**Identification cards — Contactless
integrated circuit cards — Proximity
cards —**

**Part 4:
Transmission protocol**

AMENDMENT 1: RFU handling rules
(standards.iteh.ai)

*ISO/IEC 14443-4:2016/Amd 1:2016
<https://standards.iteh.ai/catalog/standards/sist/3bab8e8e-bae6-420e-b017-be624618>*

Figure 5 — Coding of format byte

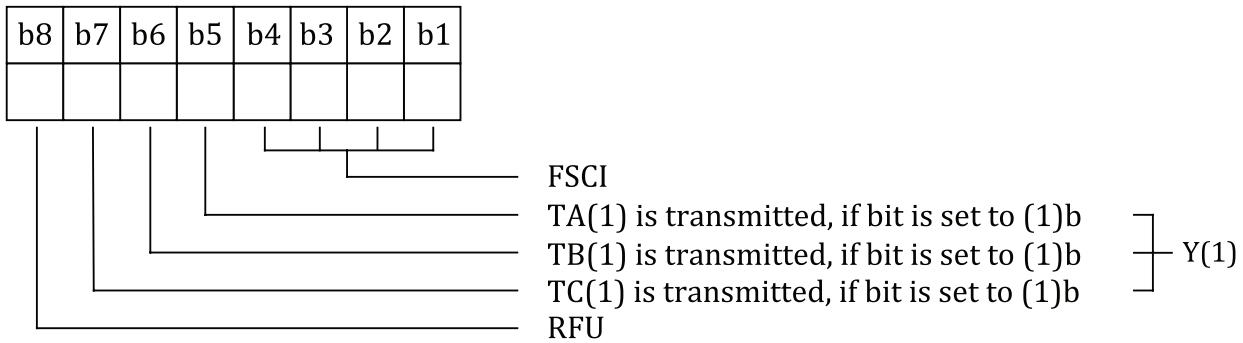
Page 7, 5.2.3

Replace the first dash with:

- “— b8 is RFU.”

Replace the fourth dash and NOTE with the following dash and NOTE:

- “— Until the RFU values ‘D’ - ‘F’ are assigned by ISO/IEC, a PCD receiving an FSCI with a value = ‘D’ - ‘F’ shall interpret it as FSCI = ‘C’ (FSC = 4 096 bytes).”

Replace Figure 5 with:

Figure 6 — Coding of interface byte TA(1)

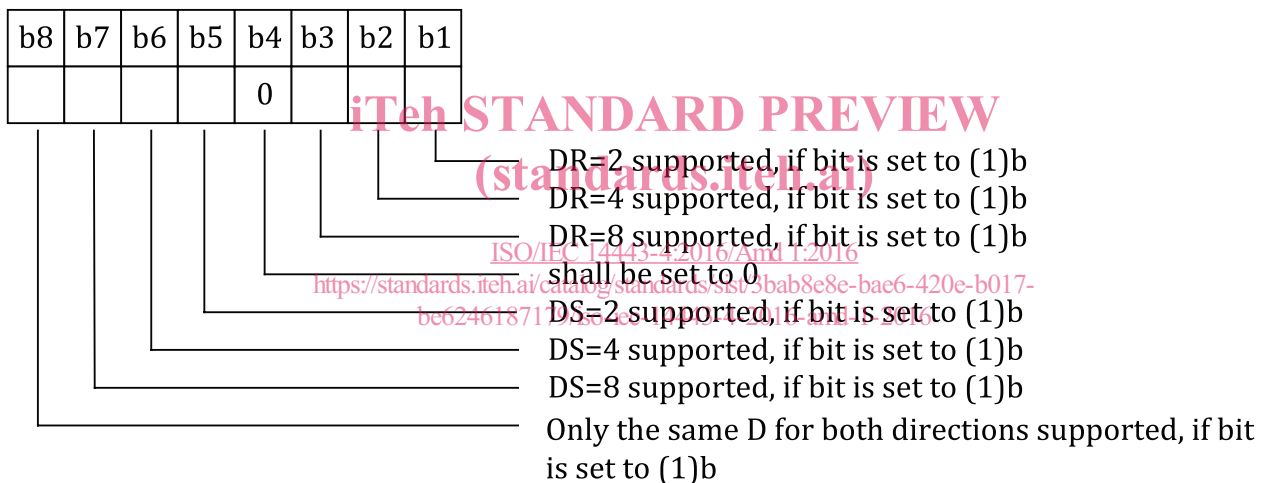
Replace the third dash with:

“— b4 shall be set to (0)b.”

Replace Figure 6 with:

Replace the last paragraph with:

A PCD receiving TA(1) with b4 = (1)b shall interpret it as (b8 to b1) = (00000000)b, implying only ~106 kbit/s supported in both directions. The definition of TA(1) with b4 = (1)b is otherwise undefined.

Figure 8 — Coding of interface byte TC(1)

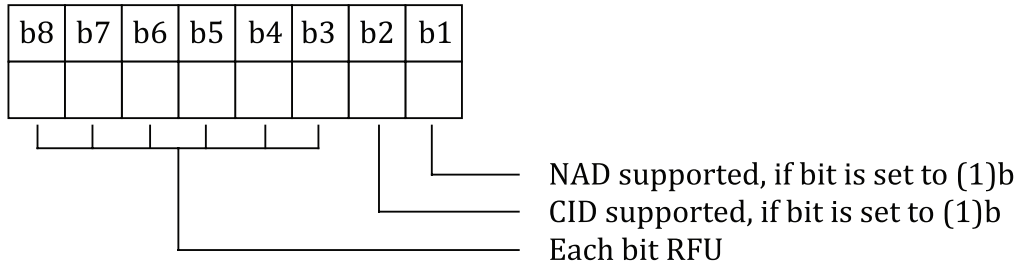
Replace the first dash of the second paragraph with:

“— b8 to b3 are each RFU.”

Delete the third dash of the second paragraph.

Replace Figure 8 with:

Figure 11 — Coding of PPS0

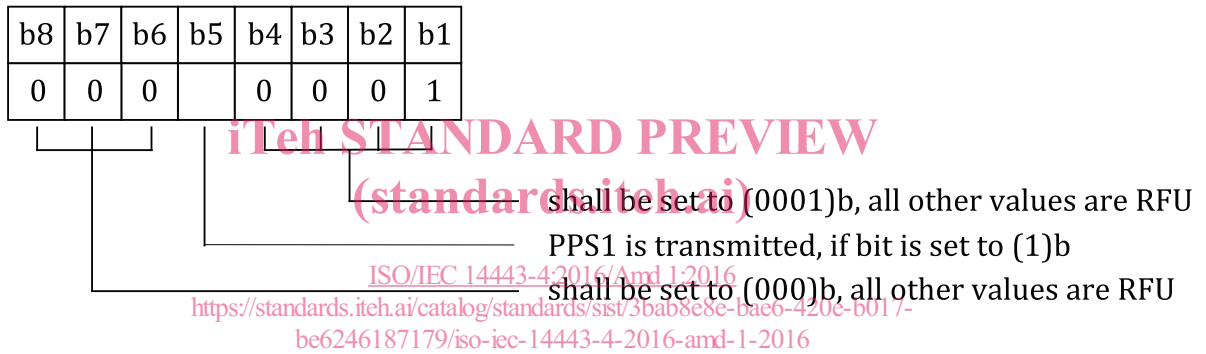
Replace the first sentence of the second paragraph with:

“The PCD shall set (b4 to b1) = (0001)b and (b8 to b6) = (000)b.”

Replace Figure 11 with:

Figure 12 — Coding of PPS1

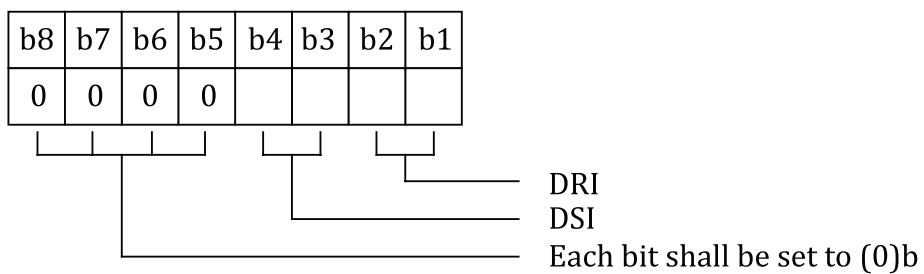
Replace the four dashes of the first paragraph with:

- b8 to b5 shall each be (0)b; a PICC receiving any bit b8 to b5 set to (1)b shall apply 5.6.2.2 (b).
- The two-bit value field (b4, b3) is called ‘DSI’ and codes the selected divisor integer from PICC to PCD.
- The two-bit value field (b2, b1) is called ‘DRI’ and codes the selected divisor integer from PCD to PICC.”

Replace Figure 12 with:

Figure 16 — Coding of I-block PCB

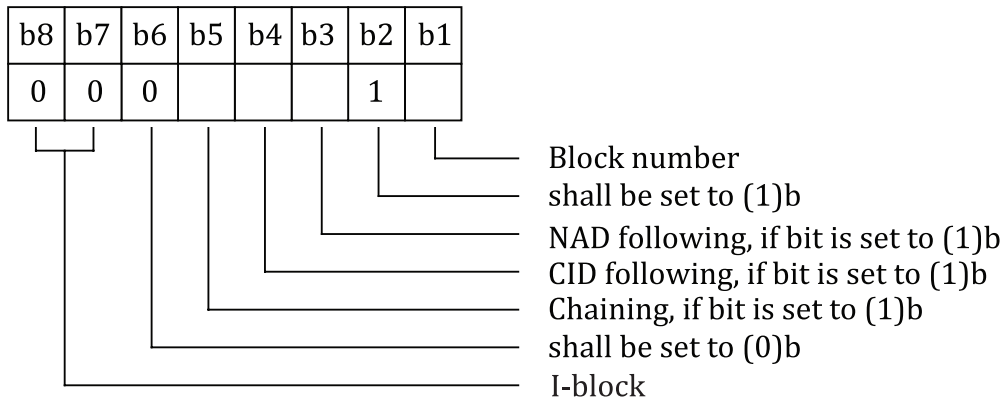
Replace the whole subclause with the following:

The coding of I-block PCB is shown in Figure 16.

A PICC or PCD receiving an I-block with b2 = (0)b shall treat it as a protocol error.

A PICC or PCD receiving an I-block with b6 = (1)b should treat it as a protocol error.

Figure 17 — Coding of R-block PCB

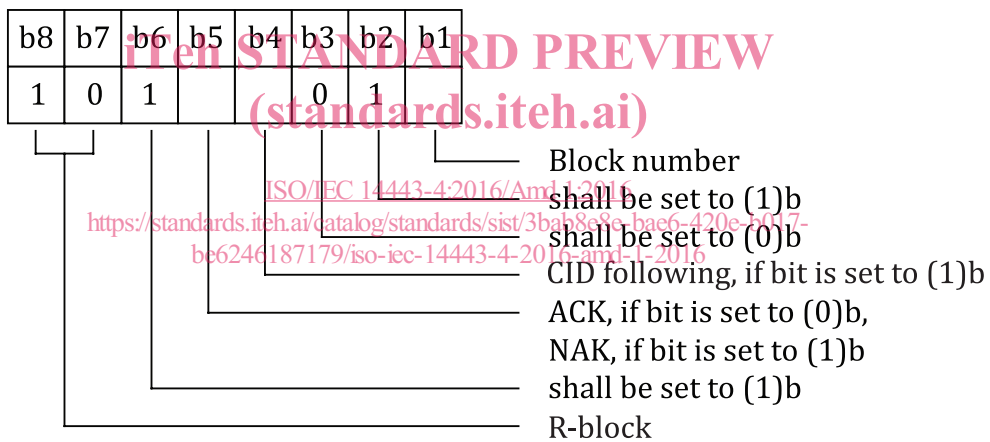
The coding of R-block PCB is shown in Figure 17.

A PICC or PCD receiving an R-block with b6 = (0)b or b3 = (1)b shall treat it as a protocol error.

A PICC or PCD receiving an R-block with b2 = (0)b should treat it as a protocol error.
